CITY OF WOODBURN
COMMUNITY DEVELOPMENT

MEMORANDUM

Date: October 5, 2020
To: Dago Garcia, P.E., City Engineer
Cc: Chris Kerr, AICP, Community Development Director
Roy Hankins, PE, Emerio Design
From: Colin Cortes, AICP, CNU-A, Senior Planner *cc*
Subject: **Planning Division review comments on 2nd submittal / 1st re-submittal
Sept. 18 of civil engineering plans for Smith Creek Development Ph. 3B**

SMITH CREEK PHASE 3B

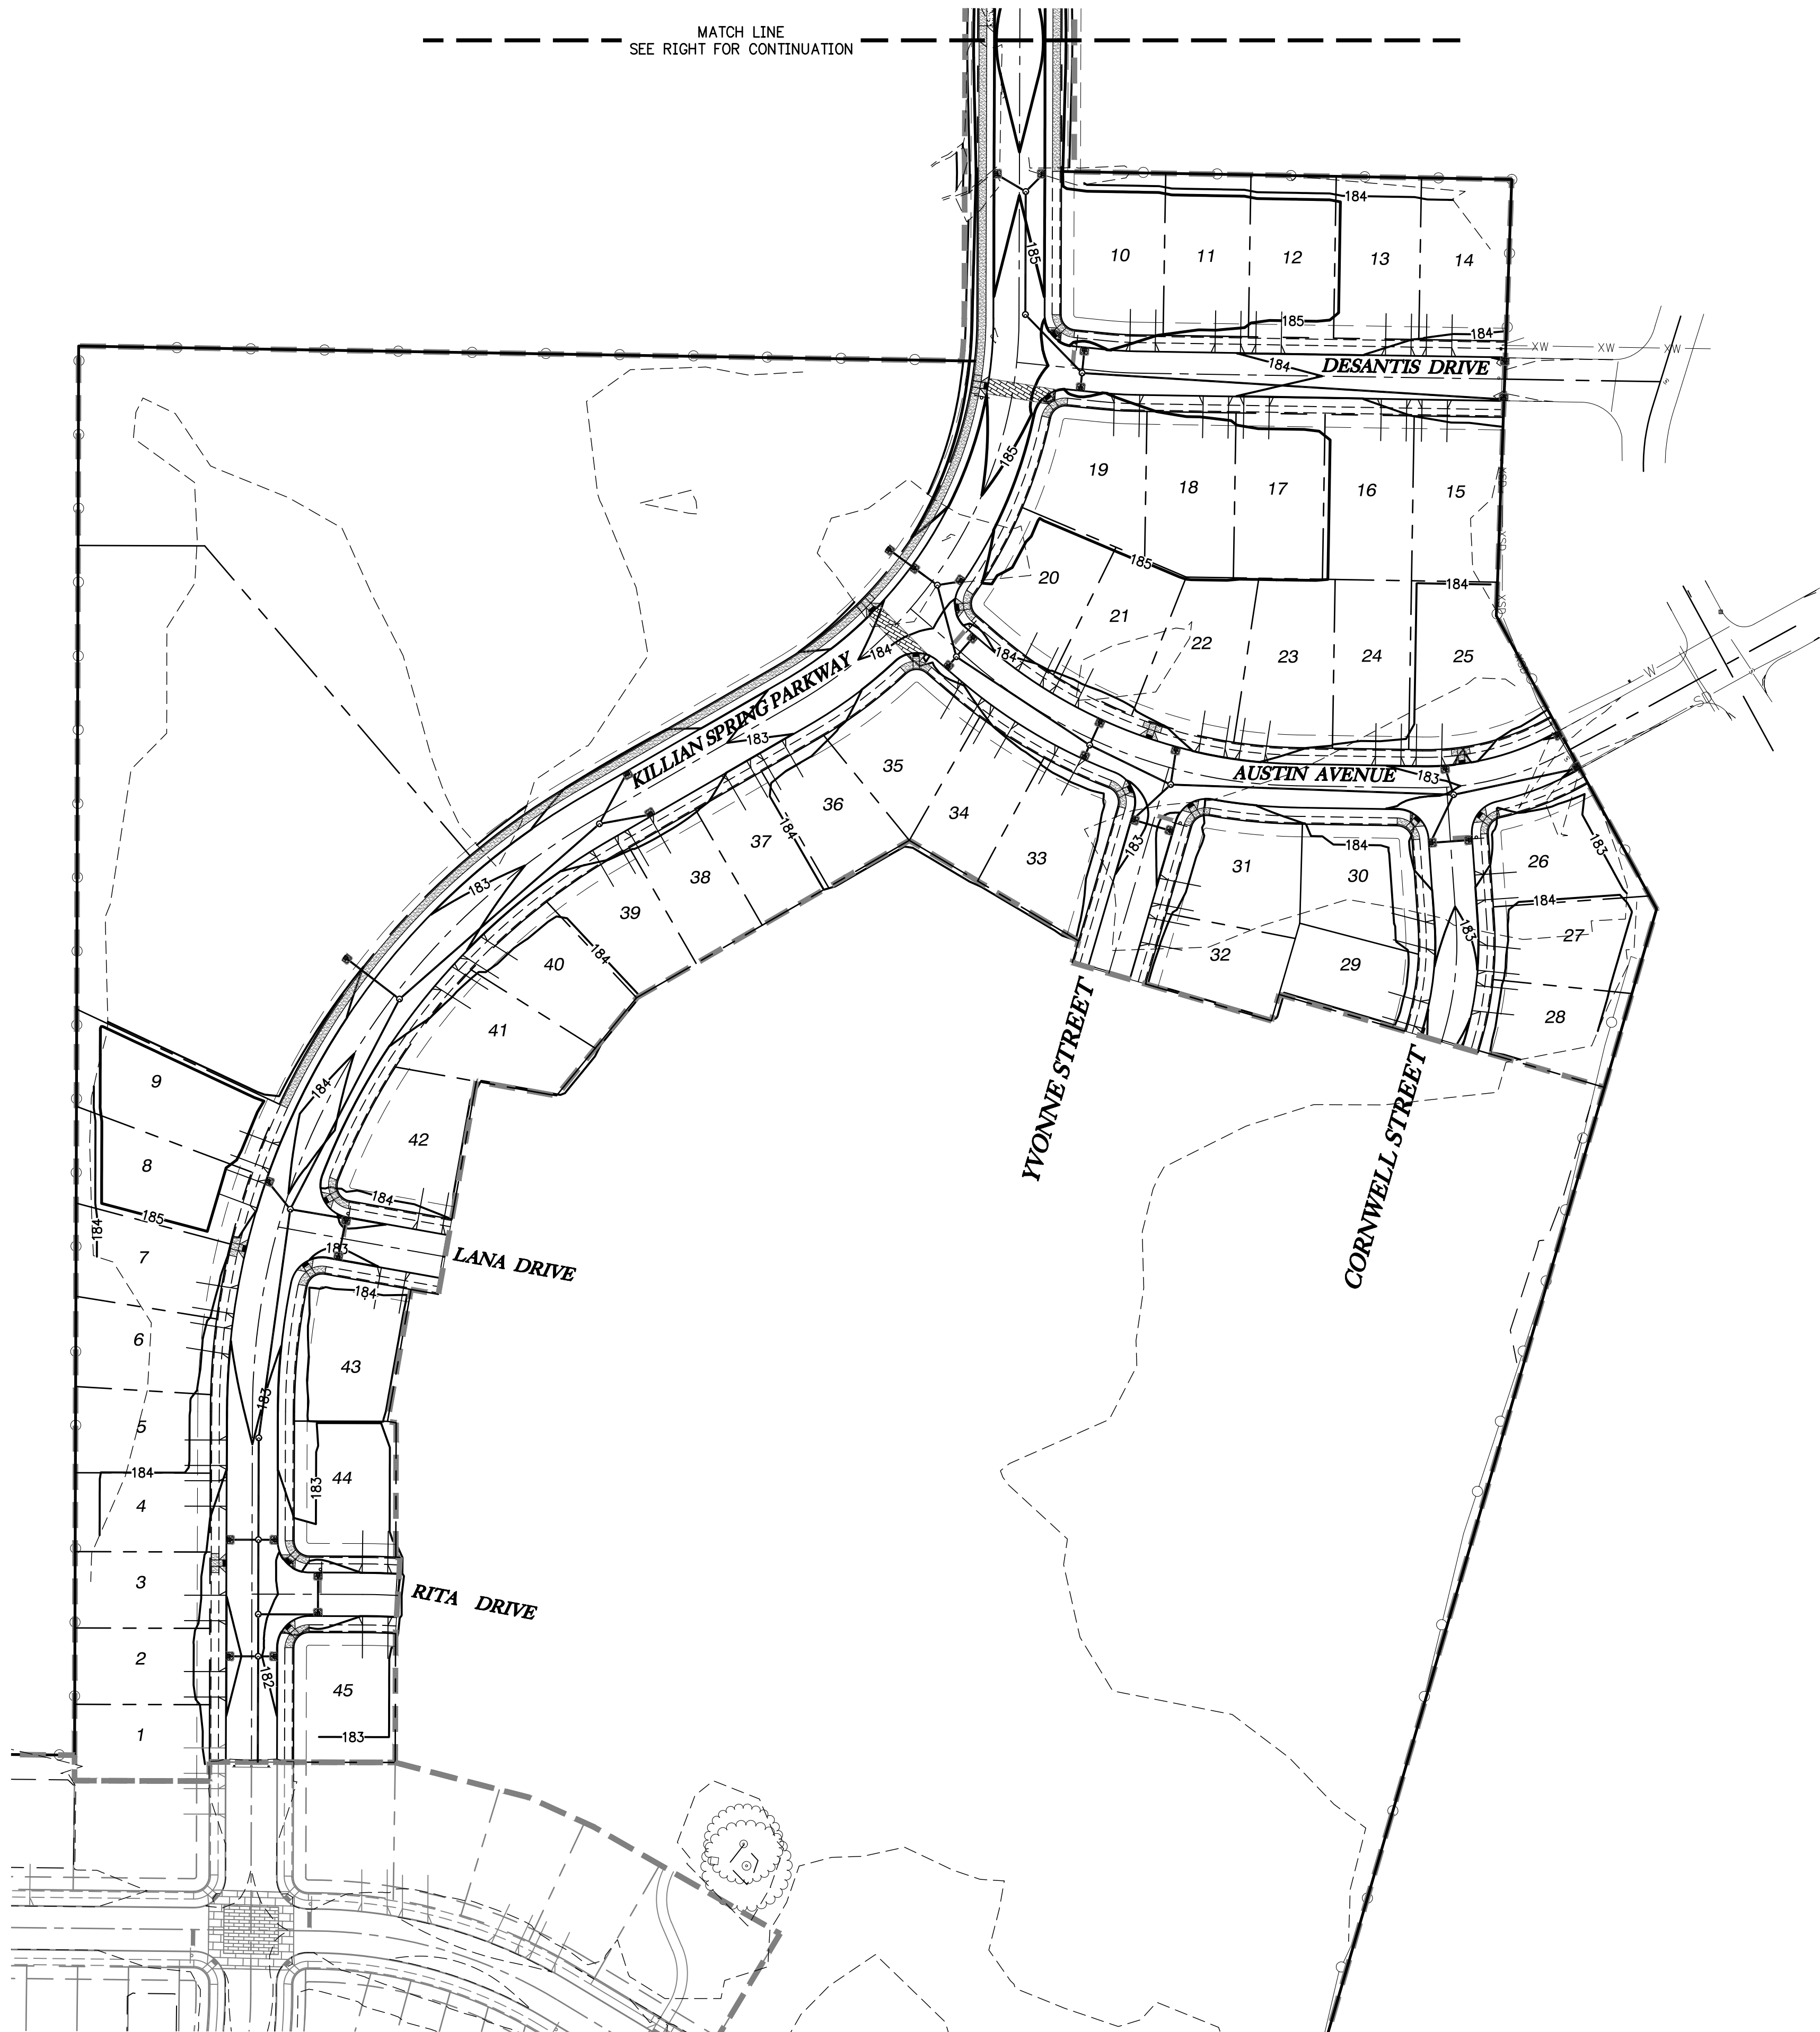
Also – and most important – the applicant having submitted Phase 3B civil engineering plans assumes that construction can meet [Smith Creek Development Final Order Condition T-A3](#) because the applicant acquired some legal right to build Killian Spring where it overlaps the church property.

If there isn't such easement, confirm and explain in a note on Sheet 4 and explain how the applicant would resolve the situation to meet the condition; if there is such easement or other legal mechanism allowing for Killian Spring to overlap the church property, revise Sheet 4 with a note or notes – including reference to the Marion County reel/volume and page numbers – to indicate and revise the drawing to delineate the extent of territory that the easement or legal mechanism covers. Also provide a copy of the recorded document.

Revise the bold dark gray dashed line, which suggests a tentative state, for the west side of tentative Killian Spring to indicate that ROW and PUE already exist.

SHEET
03
 OF
32

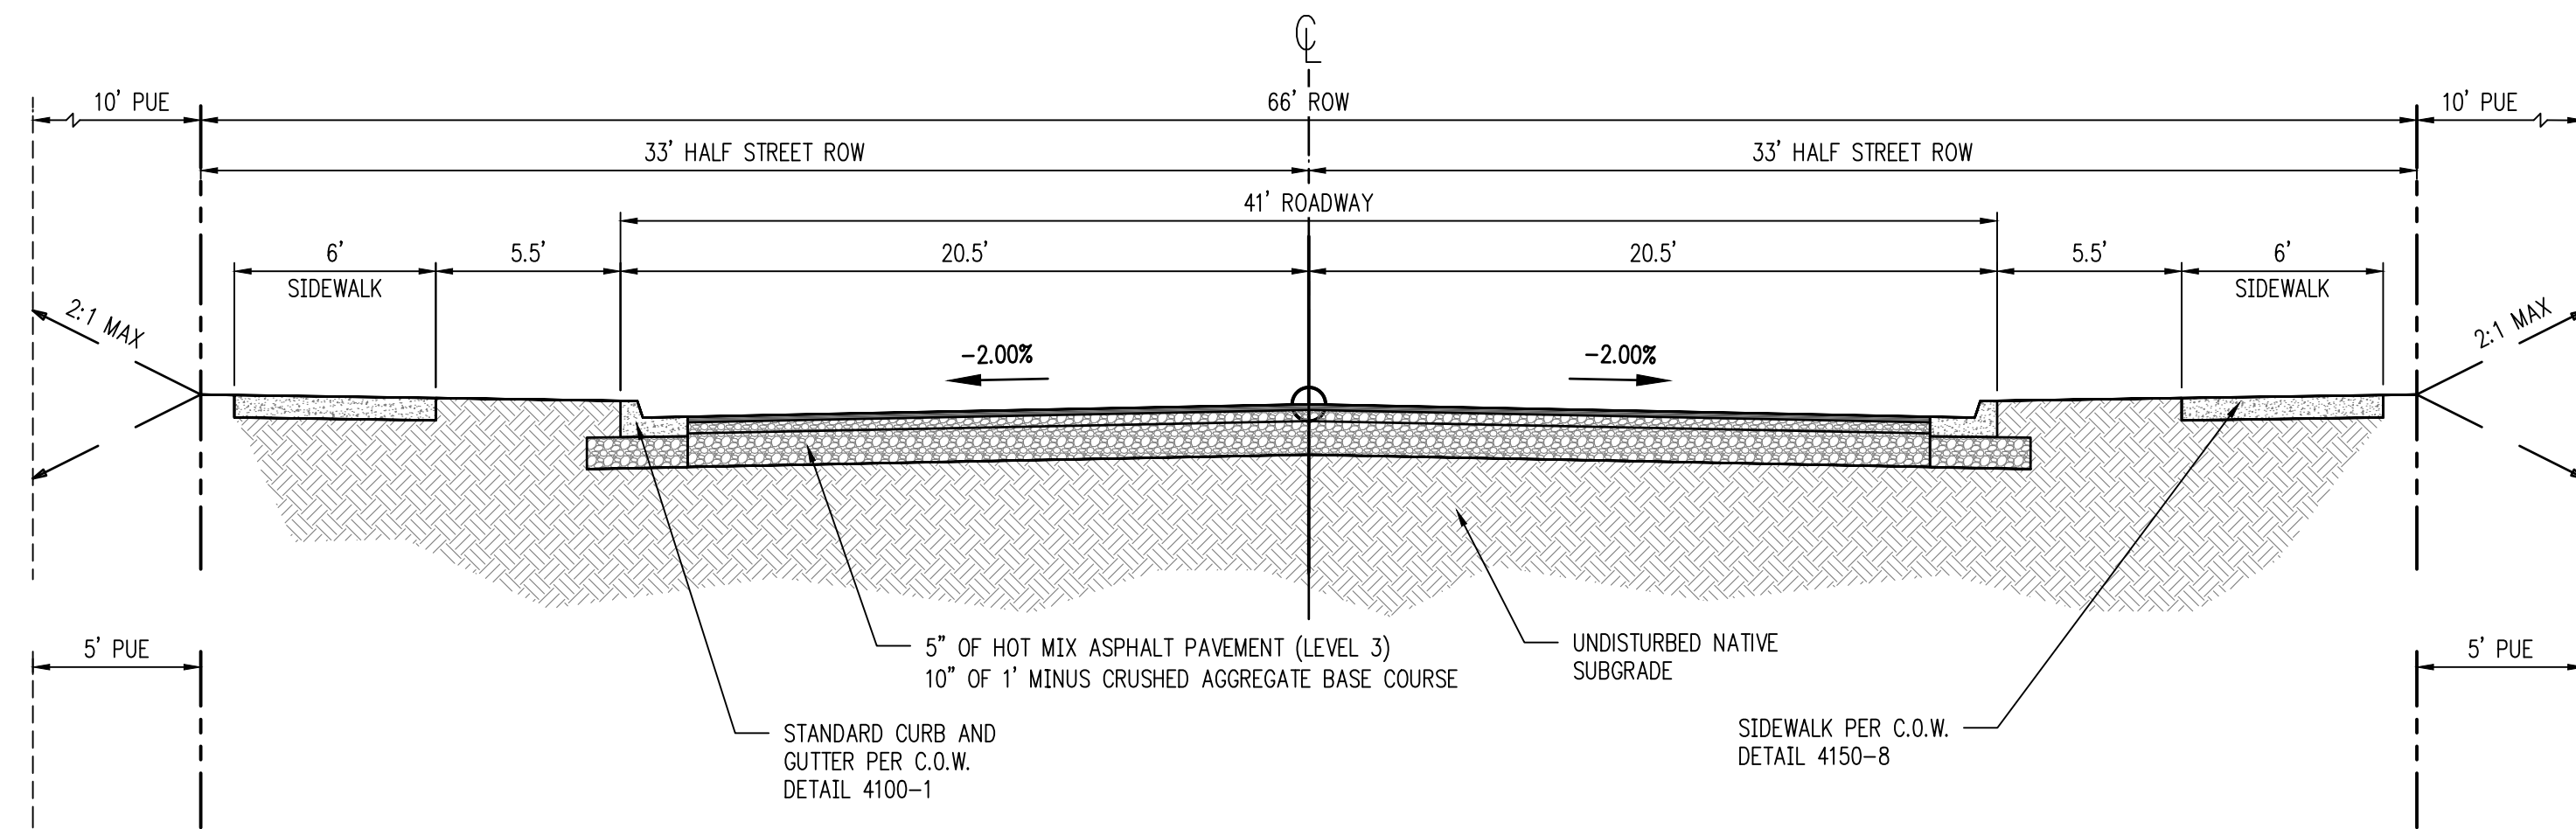
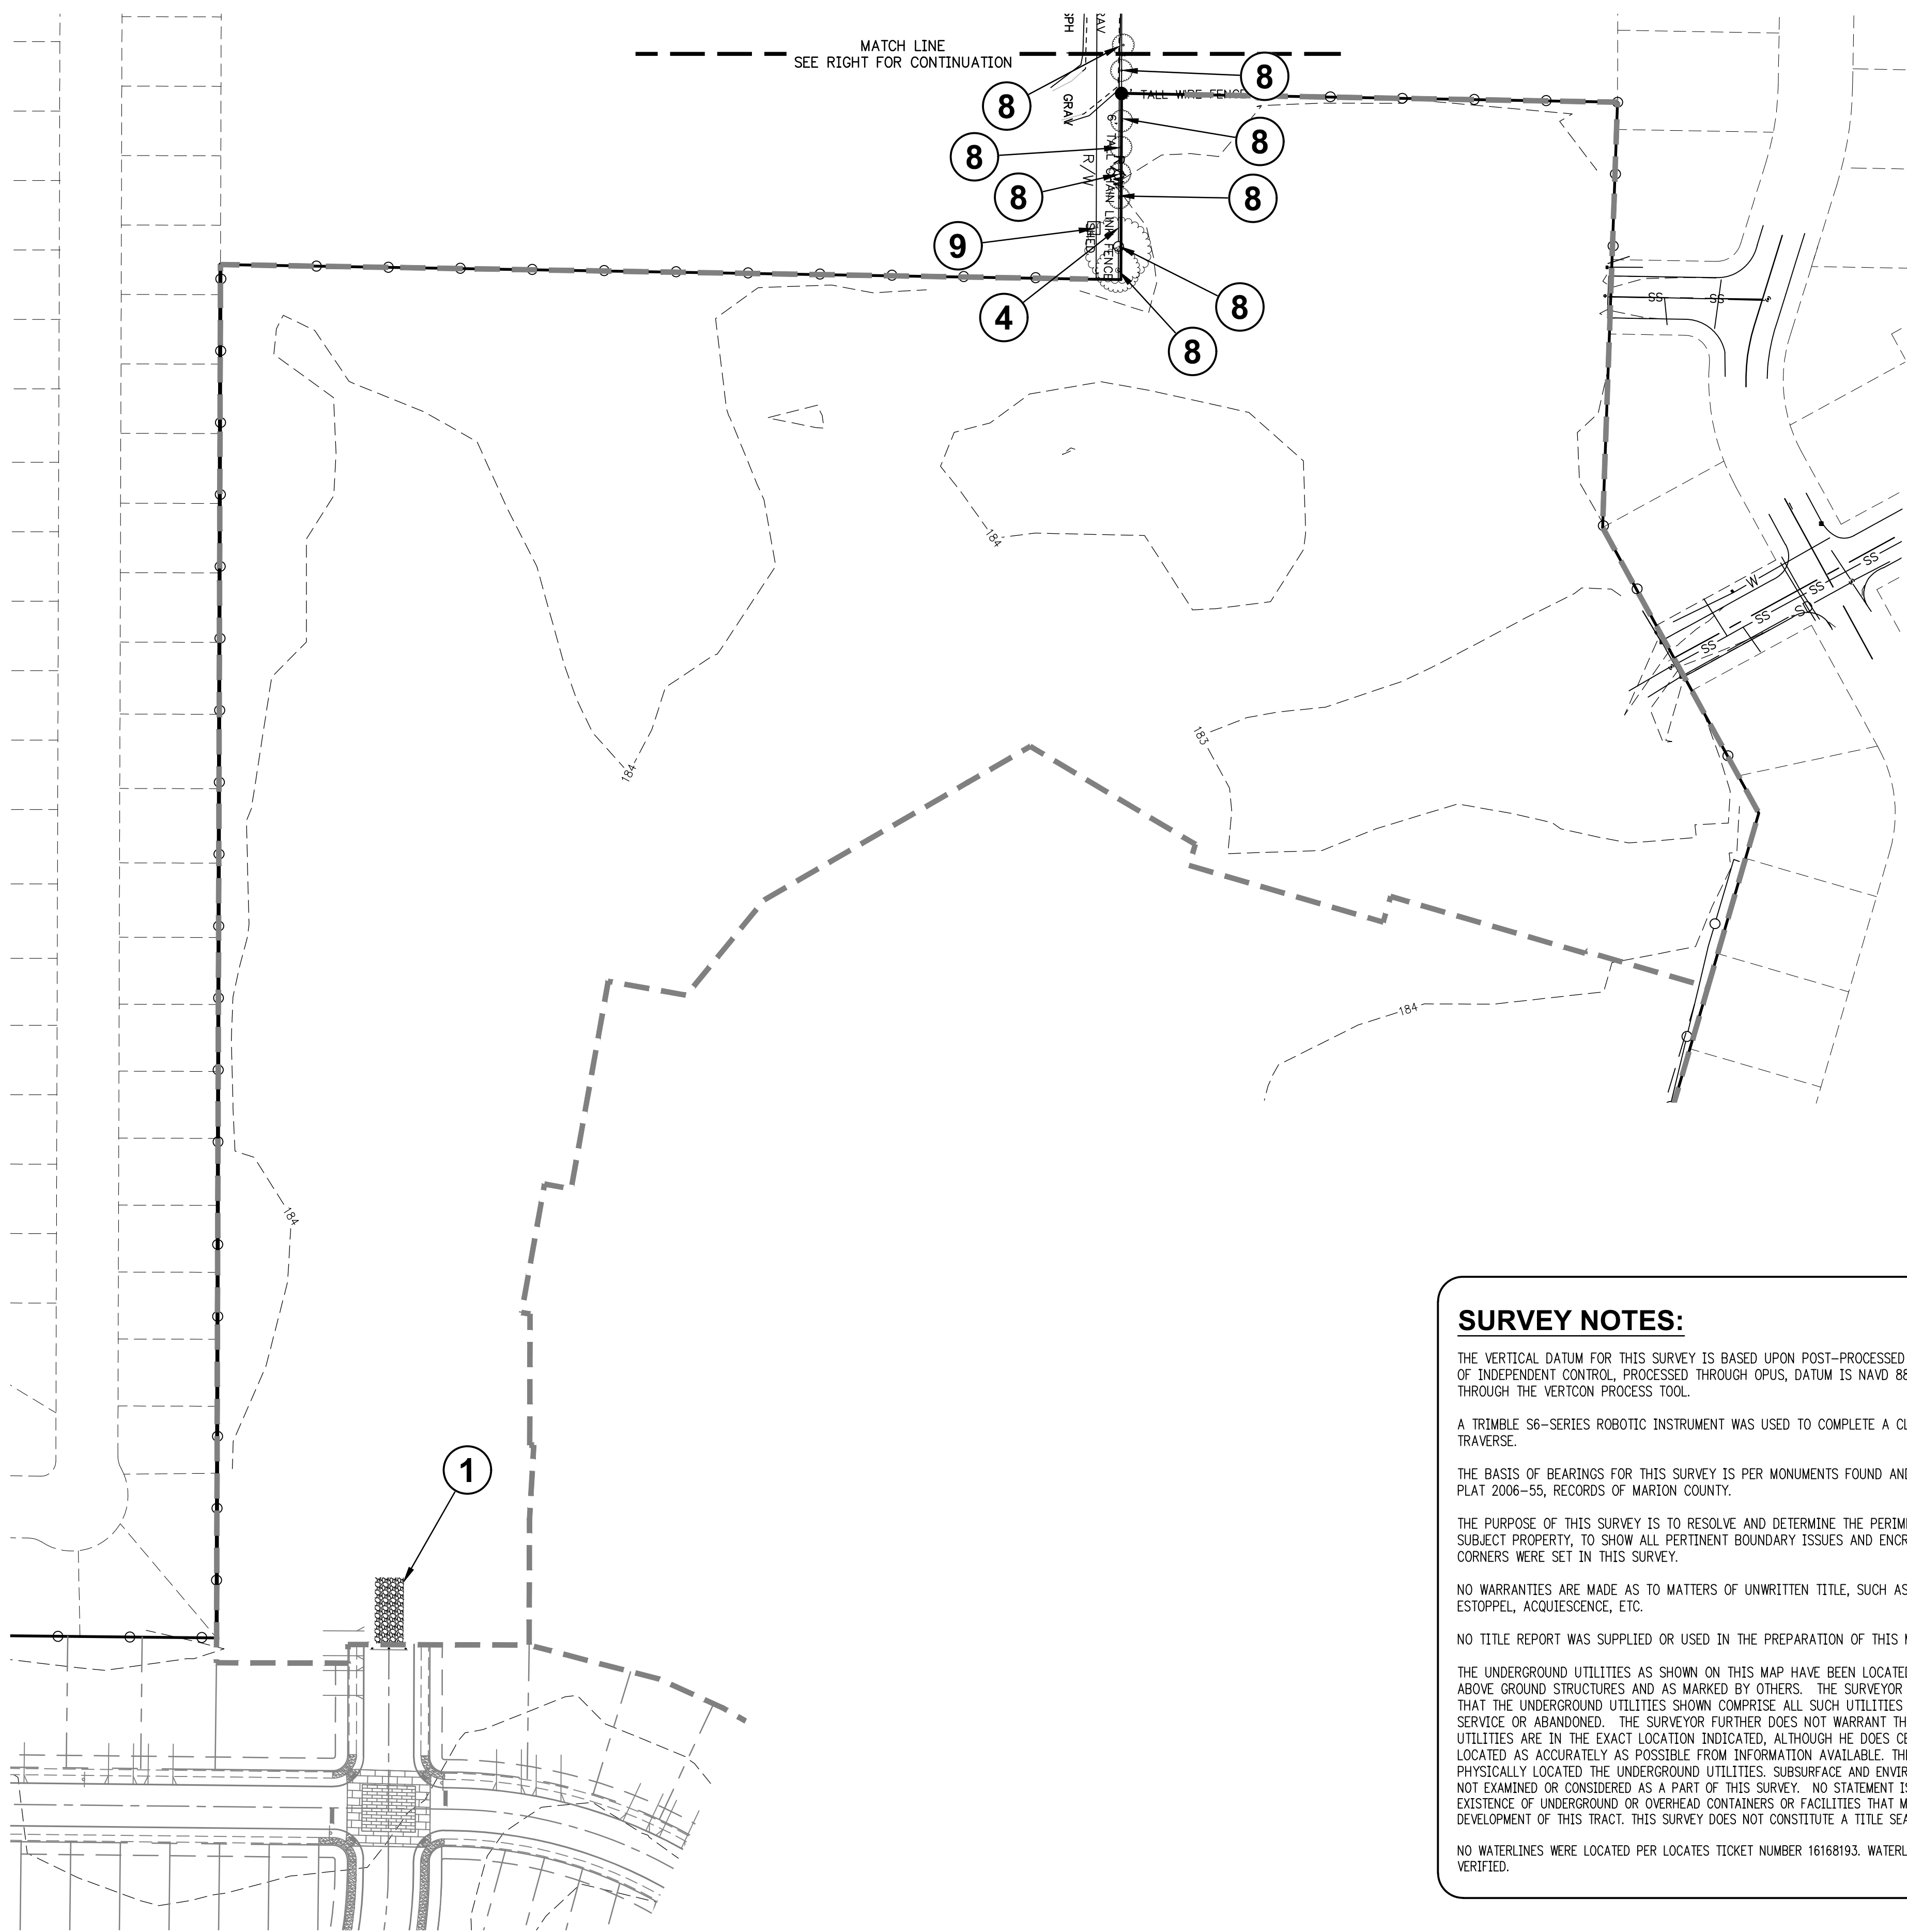
Sheet 3 is revised with a crosswalk plan detail of color and pattern:

The detail shows for crosswalk not Davis Colors 160 Brick Red, but Davis Colors 1117 Tile Red, which is a minor modification that staff notices and hereby accepts:

However, the detail doesn't fully conform to the Planning staff memo dated August 23, 2019 sent to the City Engineer and cc'd to both Morgan Will of Stafford Land Co. and the applicant civil engineer, Roy Hanks, PE, of Emerio Design. It's re-attached. Though this memo was for Planning staff Phase 1A civil engineering plans review, the staff memo dated June 8, 2020 for Planning staff Phase 3B civil engineering plans review (original submittal) confirmed that the standards established for 1A apply also to later phases and attached the August 23, 2019

Other crossings: The revised Sheet 3 lacks indication of Mill Creek Greenway Trail crossings of streets being Willow Green 5376 and the middle of the intersections to be treated being Harvest Gold 5084. Both are vendor options also for concrete pigmentation per www.daviscolors.com/concrete-colors/:

Revise Sheet 3 accordingly.

Patterns: The pattern does not match any of the approved patterns. Thumbnail views of Attachment 1P are below:

Revise Sheets 3 & 16 accordingly.
